Staff Report

Re: PLNPCM2019-00264, Sugar Alley Conditional Building and Site Design Review

Conditional Building and Site Design Review

PROPERTY ADDRESS: 2168/2188 S Highland Drive (approx.)

FIRE ACCESS SECTIONS

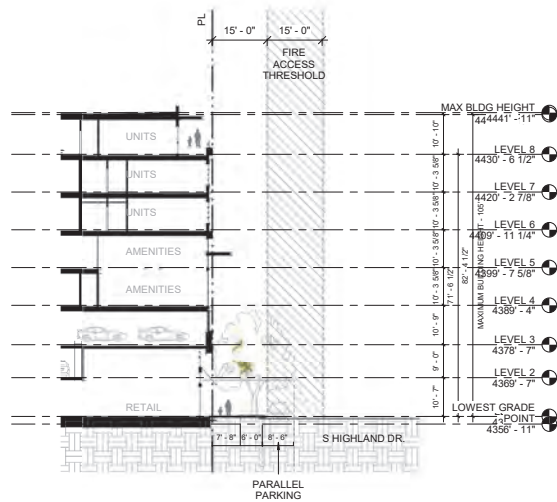
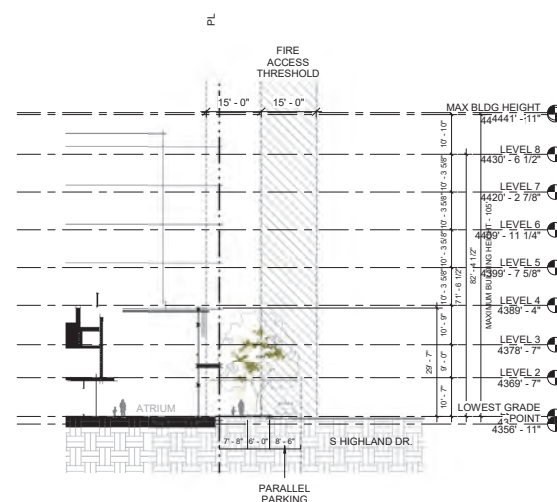
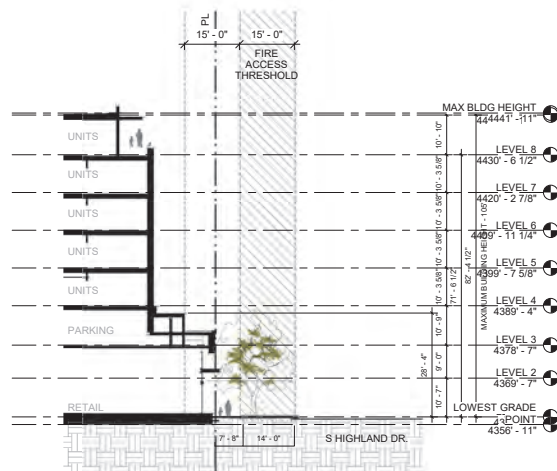
Planning Staff Note: The developer met with Fire department staff and obtained special approval for an Alternative Means and Method (AM&M), that reduces the number of fire access lanes they needed to provide from 2 to 1. They can do this as the applicant is including an automatic fire sprinkling system, reducing the necessity of an additional fire lane. This allowance is in the 2015 International Fire Code, Section D106.

Planning staff further discussed the proposal with Fire staff. Fire staff identified that the full upper level 15' step-back on the south-east corner would not be allowed by Fire code, as it puts that face of the building more than 30' away from Highland Drive. Fire code requires that the building not be any further than 30' from the "fire apparatus access" lane (Highland Drive.) This requirement is in "Appendix D" of the International Fire Code under section D105.1. Staff discusses this issue in [Consideration 1](#) and has included a condition of approval that allows Planning staff to reduce the step-back as necessary to meet Fire Code requirements. Planning staff anticipates that the final step-back will be approximately 10' in depth, rather than the full 15', to meet minimum Fire Code requirements.
